STAFF REPORT

HEARING DATE: May 9, 2023

SUBJECT: H-2022-0066
Artisan Victory Market – AZ, CUP, PP, & PS

BARON DEVELOPMENT
CUP LANDSCAPE PLAN

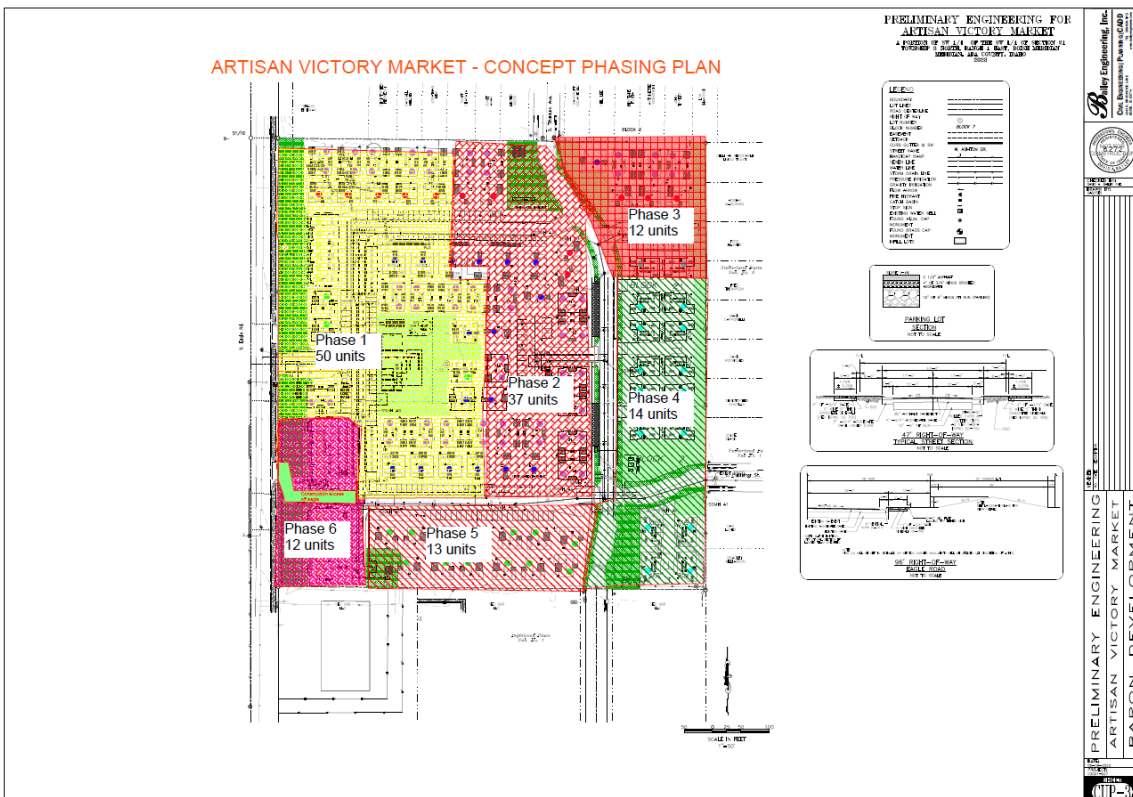
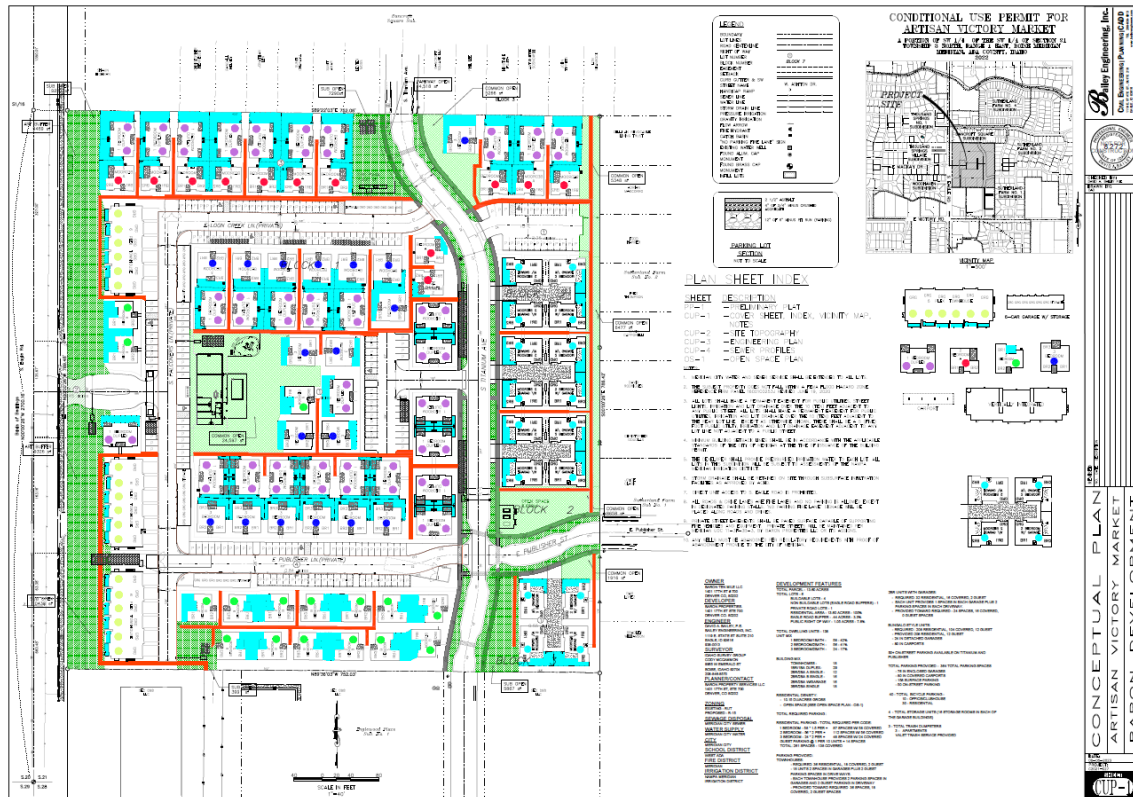
There are existing trees on the site to be removed or that require mitigation. **The landscape plan submitted with the final plat should include the detail mitigation plan in accord with UDC 11-3B-10.**

- a. The landscaped area shall be at least three feet (3') wide.
- b. For every three (3) linear feet of foundation, an evergreen shrub having a minimum mature height of twenty-four inches (24") shall be planted.
- c. Ground cover plants shall be planted in the remainder of the landscaped area.

The landscape plan submitted with the Certificate of Zoning Compliance application should depict landscaping in accord with these standards.

3. The landscape plan submitted with the final plat shall be revised as follows:
 - a. Landscaping is required within the street buffer as set forth in UDC [11-3B-7C](#). *(See updated standards.)*

6. The landscape plan submitted with the final plat shall include the detail mitigation plan in accord with UDC 11-3B-10.
7. All structures on the property shall be removed for the site with development of the subdivision.

B – Dog Park

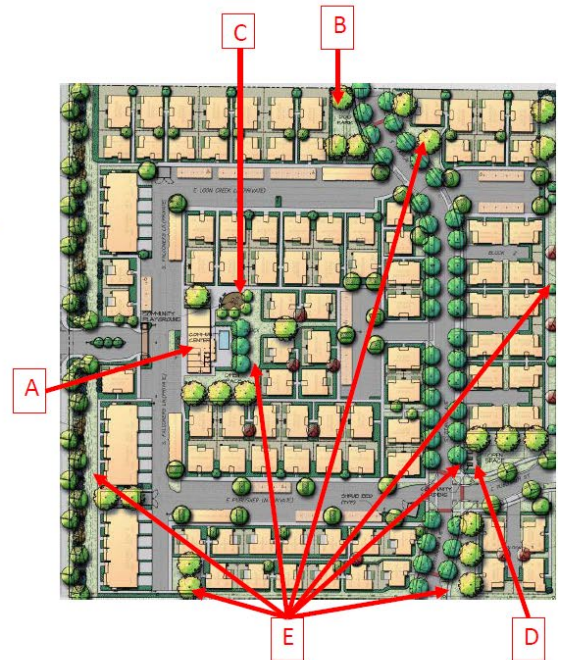
Proposed amenities include a clubhouse with a fitness facility, a swimming pool, an outdoor lounge area, dog park, internal walking trails, community garden and passive open space areas. Another amenity should be included in the development since the applicant is proposing over 100 units. Of the amenities included in the development, there isn't one listed from the multi-modal category above. Therefore, staff recommends that the applicant add one additional amenity from the multi-modal category above and include the amenity on the site plan submitted with the certificate of zoning compliance application.

- h. Provide amenities for the development as shown in Exhibit VII.F. The applicant shall provide another amenity from the multi-modal category and provide a detail of the amenity with the CZC submittal.
